ADDENDUM NO. 4

Perry Meridian High School Phase 1 – Student Activity Center
401 W. Meridian School Road
Indianapolis, IN 46217

PROJECT: PERRY MERIDIAN HS PHASE 1
PROJECT NUMBER: 24173P
DATE OF ADDENDUM: April 16, 2026

RE: Addendum 04

C-5.1

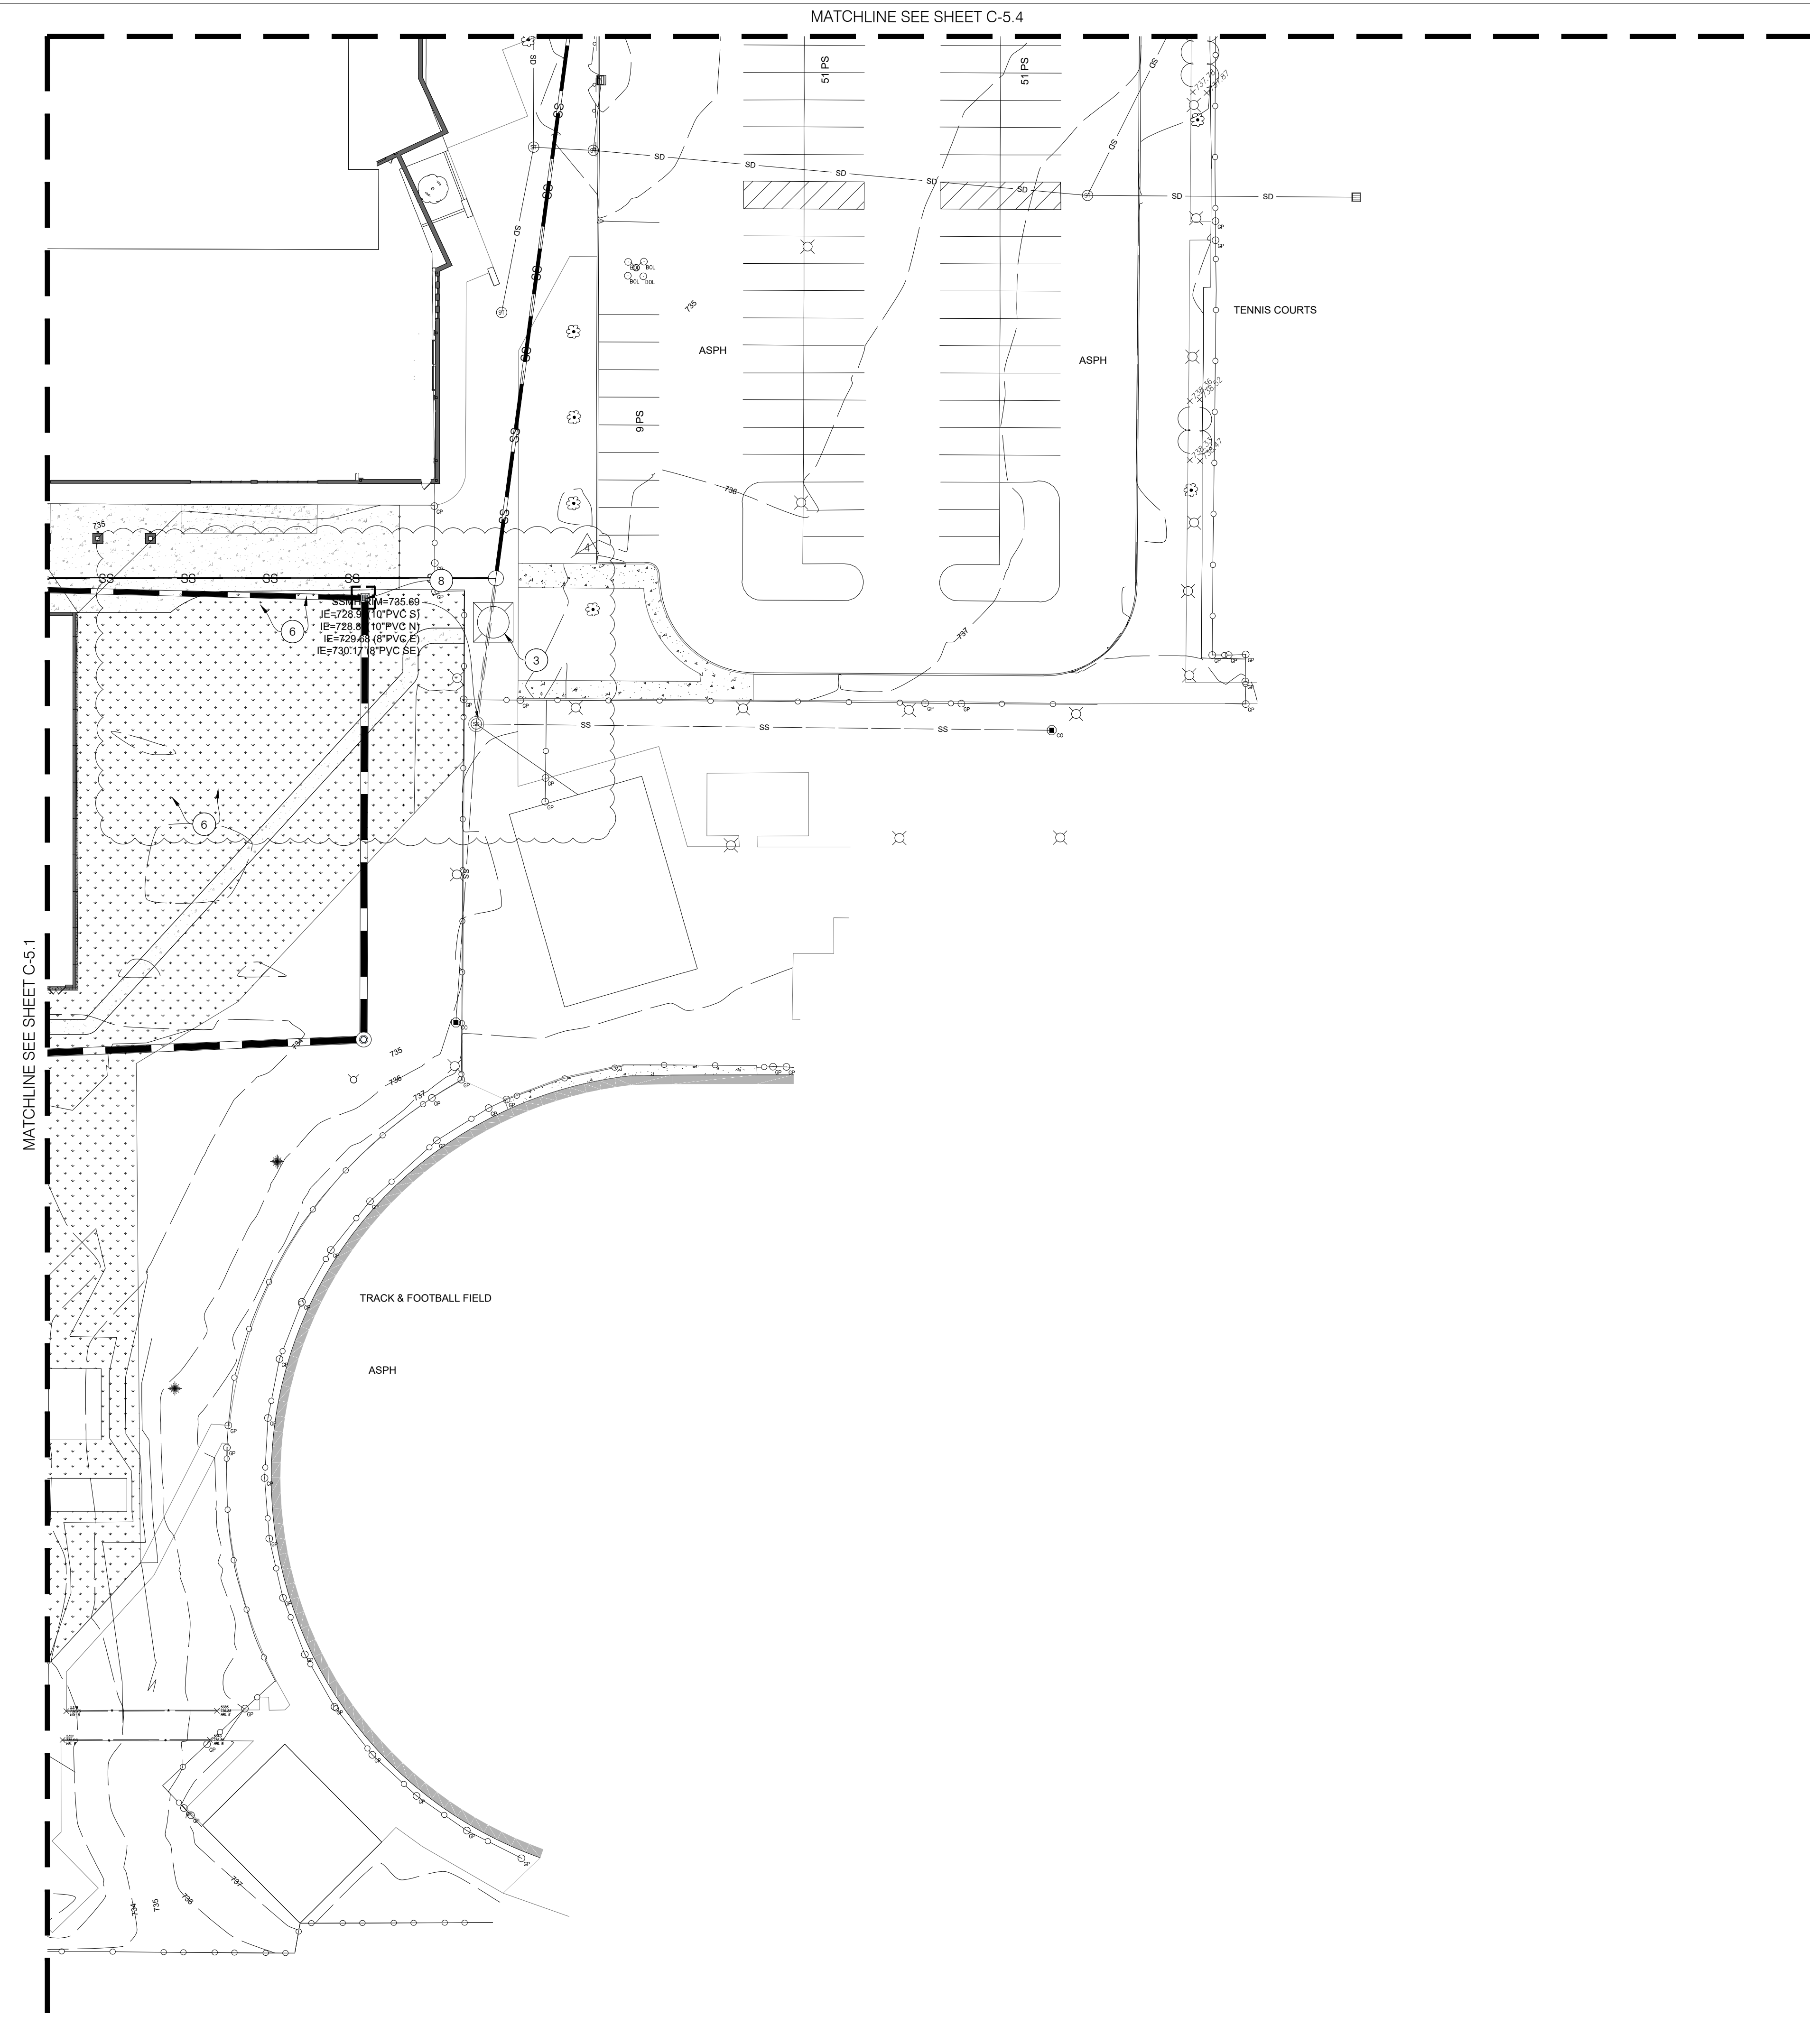
Sheet C-5.1

- Proposed storm system was added to the sheets to accurately show inlet protection.

C-5.2

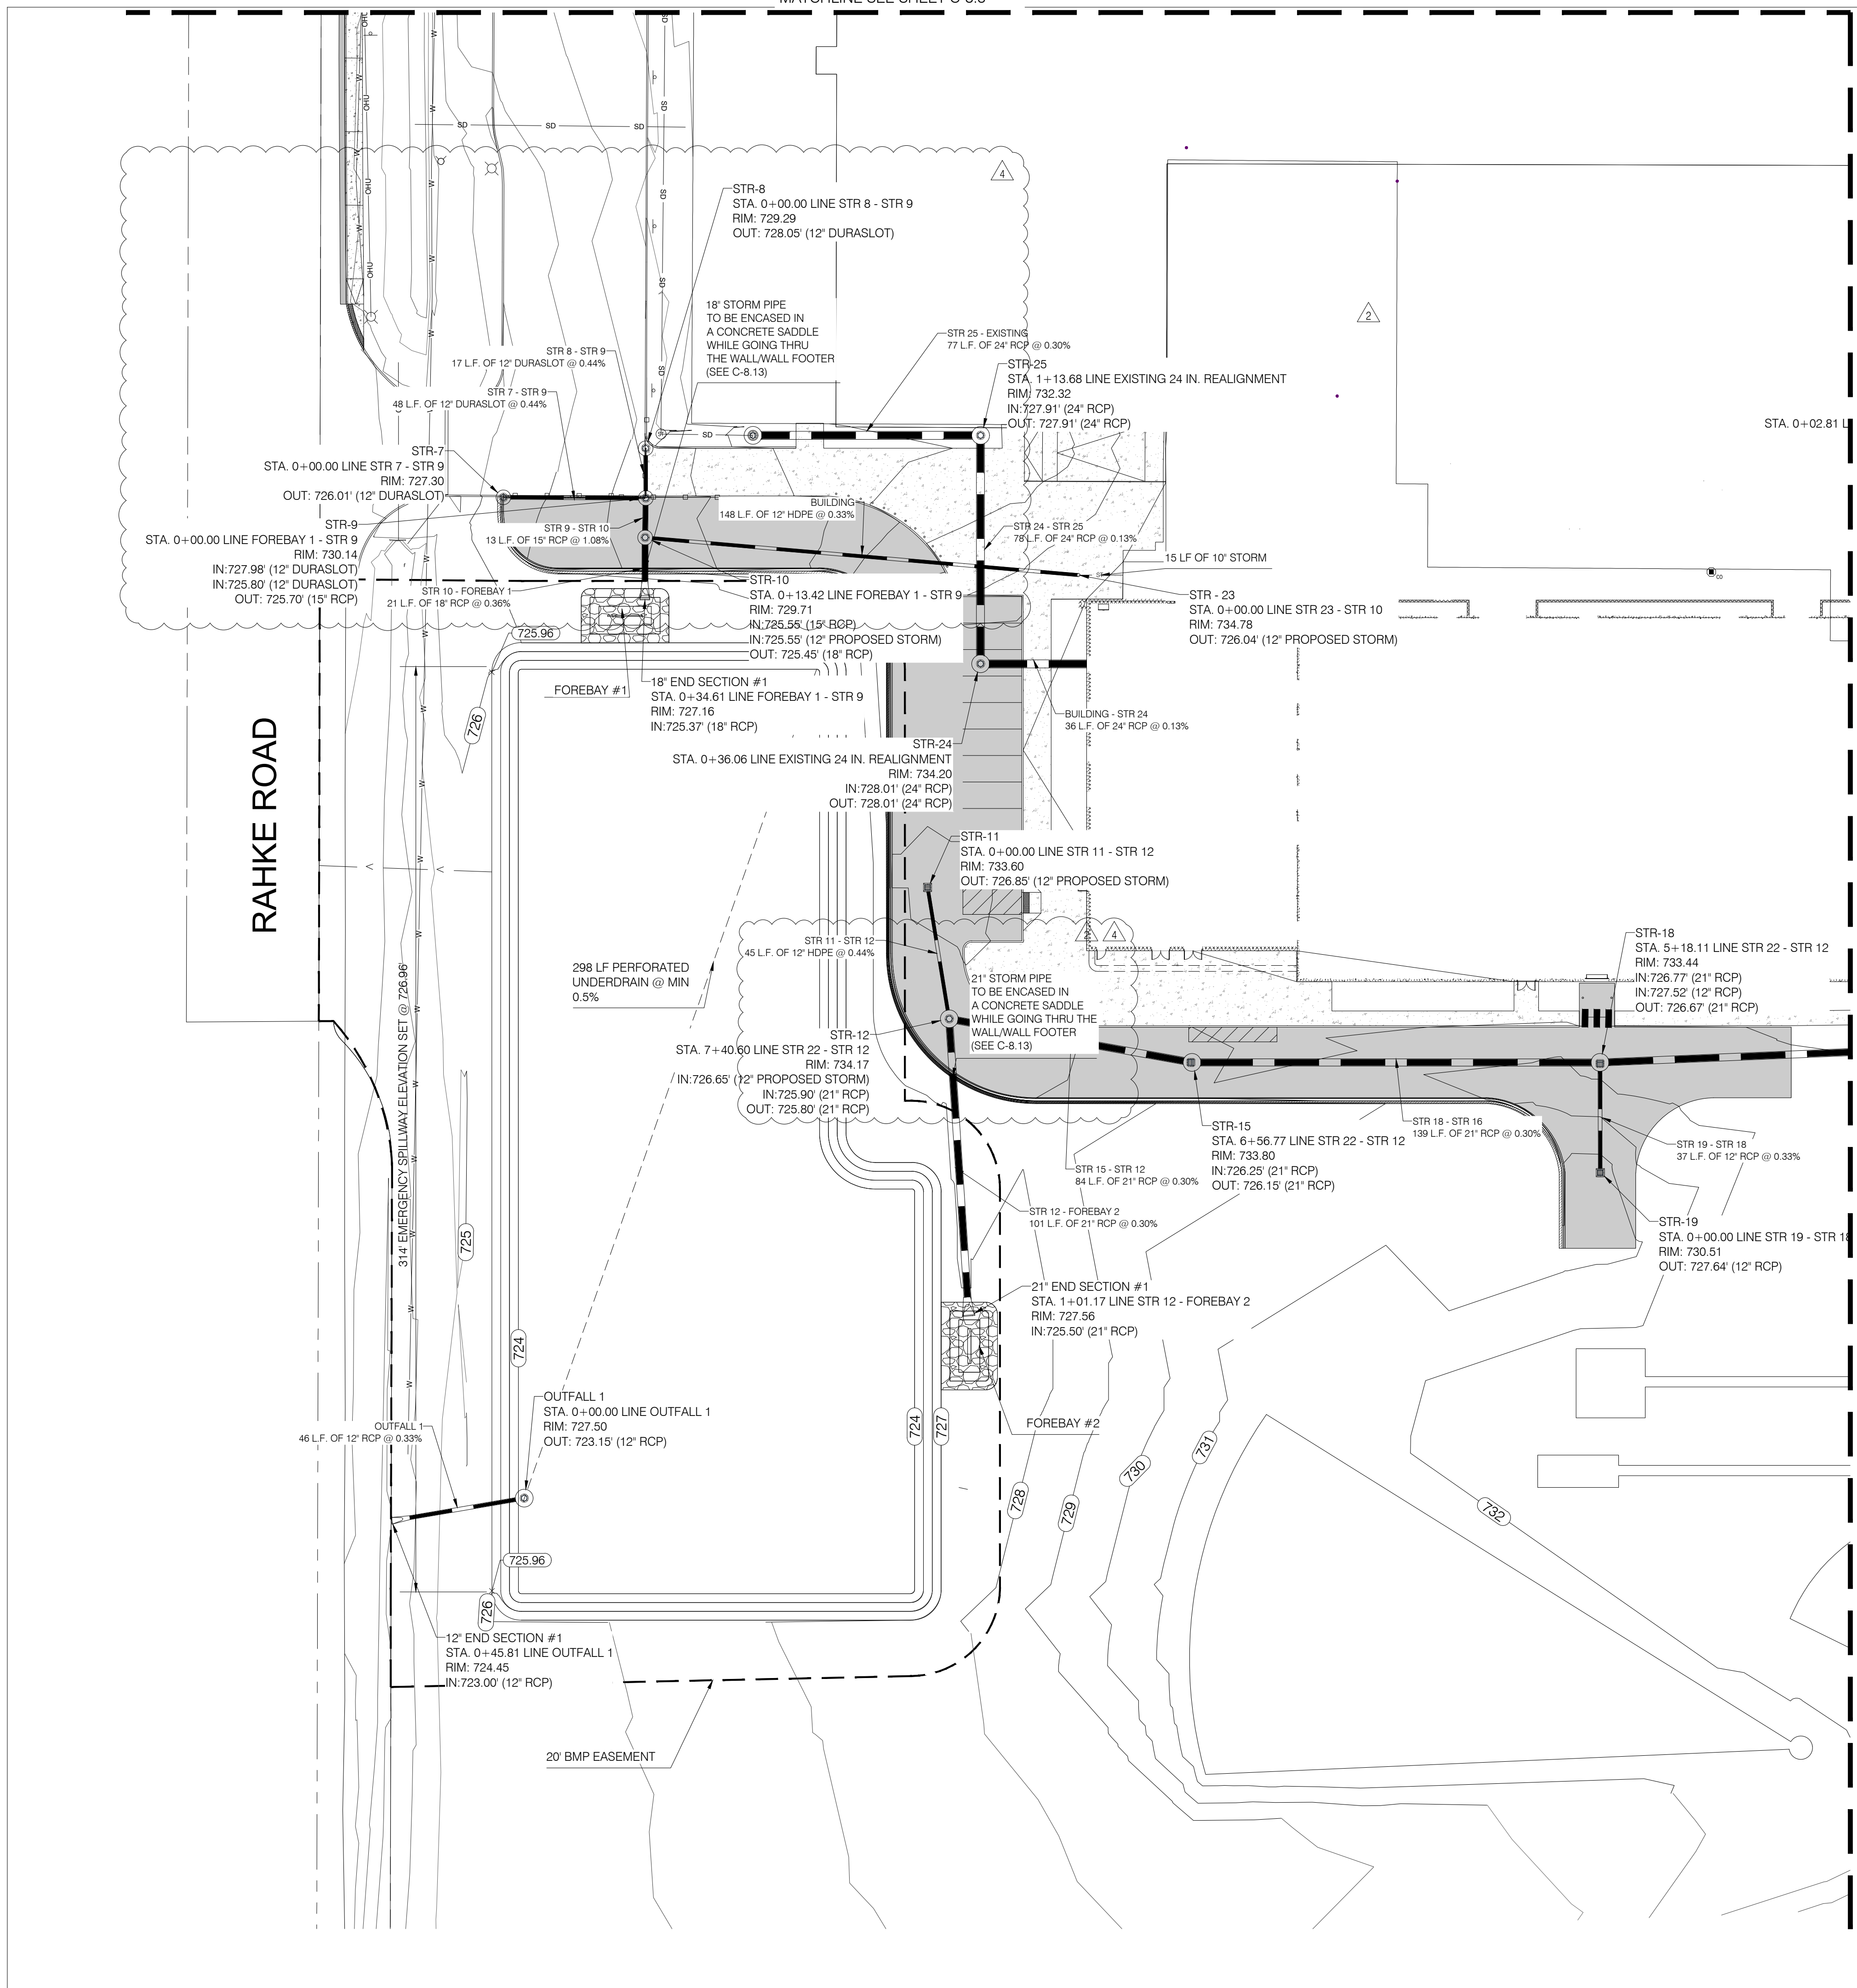
Sheet C-5.2

- Proposed storm system was added to the sheets to accurately show inlet protection.
